YOU BE THE JUDGE

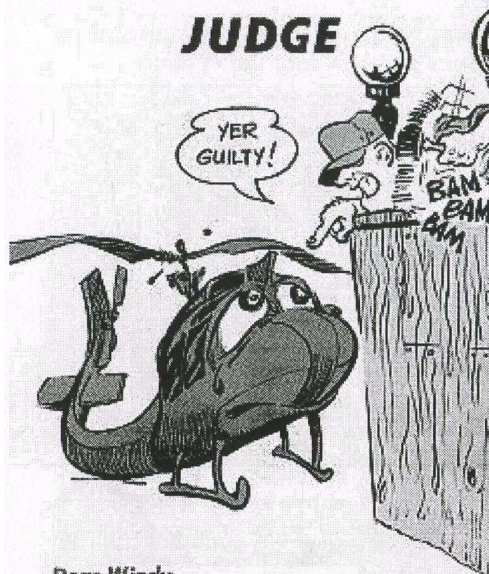
I've looked high and low—without success—for the allowable play in the Huey (UH-1D/H) droop compensator connecting link rod-end bearing, FSN 3110-73-5072.

What are the limits, Windy, which would require changing the rod end?

There're no limits because you're not allowed any play.

You'll still get some slight movement, however, when you plant your mitts on the link during a looseness check . . . no sweat!

Course, if the bearing is worn from lack of lubrication or contamination you'll have a very loose link on your hands.

Para 25 of TM 55-405-3 (12 Jul 66) lists "excessive looseness" as one of the conditions which call for a bearing change.
